TE Connectivity

Product Change Notification: P-22-022315

Transistor socket contact system supplier change

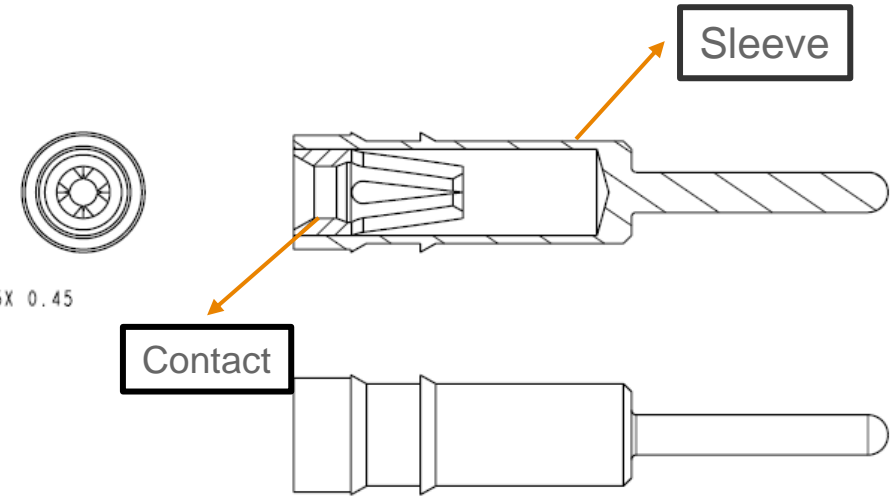
Change Description:

Contact system supplier changed for below listed finished good part numbers. Existing supplier plant closed and can not support item anymore.

1. 1-1437504-4
2. 1-1437504-6
3. 1-1437504-7
4. 1-1437504-8
5. 1437504-6
6. 2-1437508-9

Supplier change is only based on dimension qualification and as per supplier provided Spec(see notes).

On checking with customers, No specific requirements and not done any reliability validation.

NOTES :

1. INNER SPRING CONTACT ACCEPT \varnothing 0.4 TO 0.56 OR RECTANGULAR PIN 0.25X 0.45
2. MECHANICAL DATA WITH A \varnothing 0.43 TEST PIN :
 - INSERTION FORCE: 320GR. MAX
 - EXTRACTION FORCE: 50GR MIN.
3. MECHANICAL LIFE : 100 CYCLES MIN.
4. ELECTRICAL DATA:
 - RATED CURRENT-3A
 - MAX WORKING VOLTAGE- 100V RMS/150 VDC
 - CONTACT RESISTANCE- 10M Ω MAX
5. TEMPERATURE RANGE:-55°C TO +125°C
